**From:** Christel du Preez <christel@sasenvgroup.co.za>  
**Sent:** Thursday, 21 January 2021 11:44 AM  
**To:** Liandra Scott-Shaw  
**Cc:** Veronique Fyfe; Stephan Jacobs; Jana Liebenberg  
**Subject:** RE: 16235 Kudusberg Split Part 2 Amendment process ((DEFF Reference Number: 14/12/16/3/3/1/1976/AM2))

This existing road was not reflected on previous layouts, but was accessed during the Kudusberg Split Part 2 Amendment process (DEFF Reference Number: 14/12/16/3/3/1/1976/AM2).

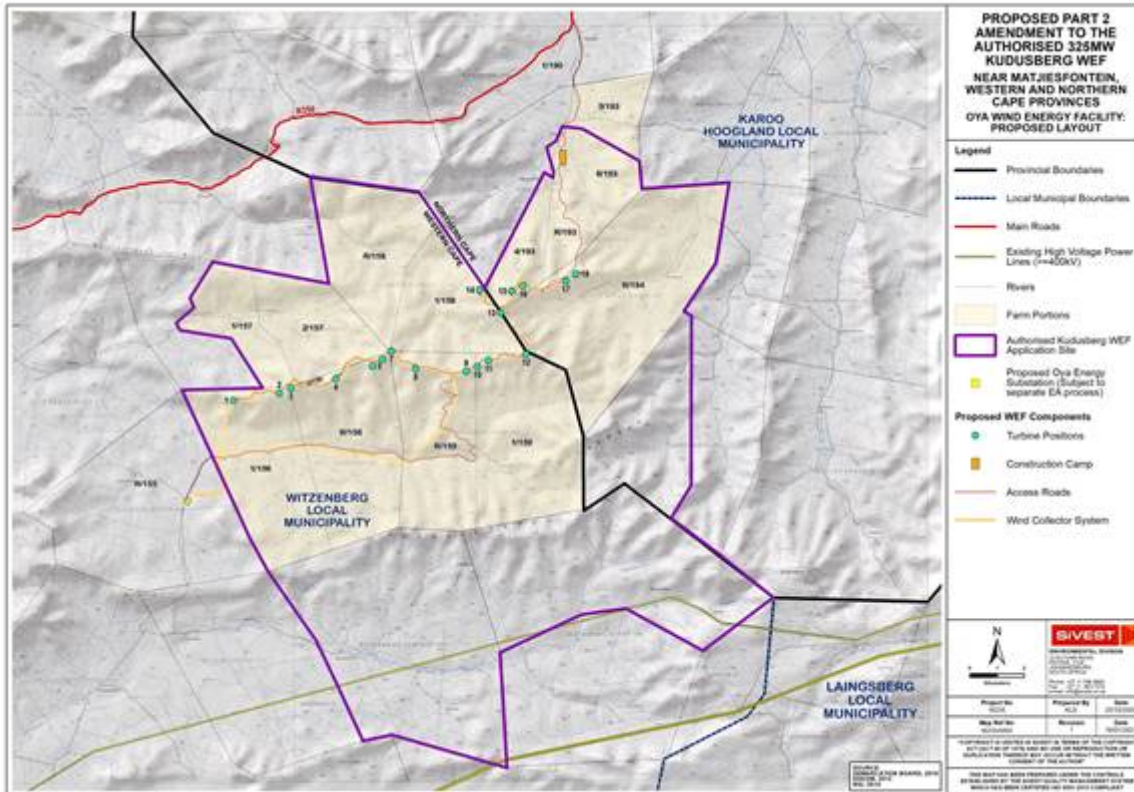
Please see the map below and attached for ease of reference:

The roads will be maintained (re-gravelled) during construction and operation but will not be widened and as such do not trigger any listed Activity under the National Environmental Management Act (NEMA): Environmental Impact Assessment (EIA) Regulations of 2014 as amended.

Please confirm if this road will have any bearing on your specialist findings.

If no NEMA activities are triggered, as per your email, then I don't foresee the need to add the road to the freshwater ecological report.

I mentioned to Stephan in a call earlier today that regravelling might require some form of authorisation from DWS (my colleague Jana is busy with the WUA process for Oya WEF), which will potentially require the need for a specialist study for the road to be undertaken, however we are still considering the need thereof for the WULA process or not.
